**A RENEWABLE HEAT INCENTIVE FOR NORTHERN IRELAND
ADDENDUM**

27 January 2012

Cambridge Economic Policy Associates Ltd and AEA Technology Limited

Figure 3.1: Northern Ireland biomass prices in p/kWh (delivered)

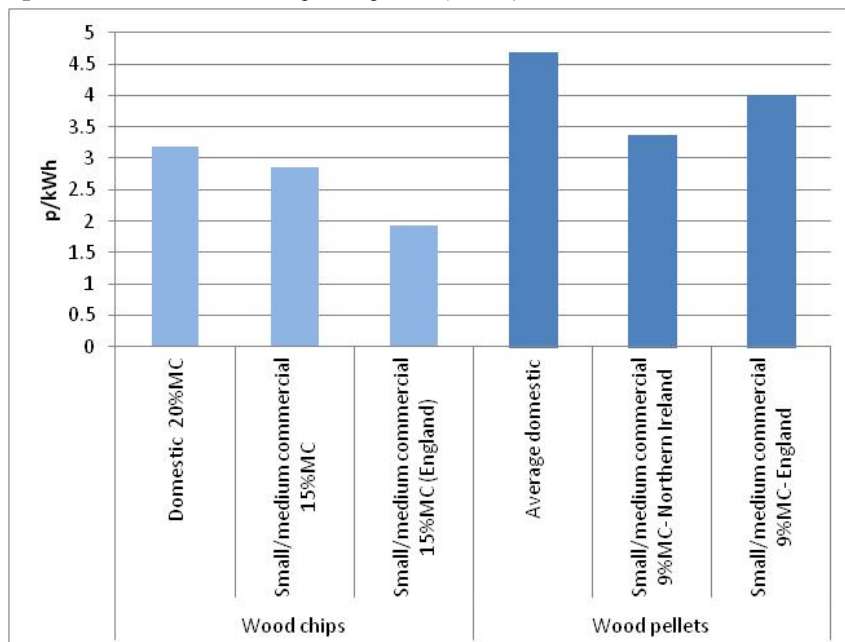
Comment [PH20]: How is this calculated?

Comment [PH21]: What about large commercial/industrial prices?
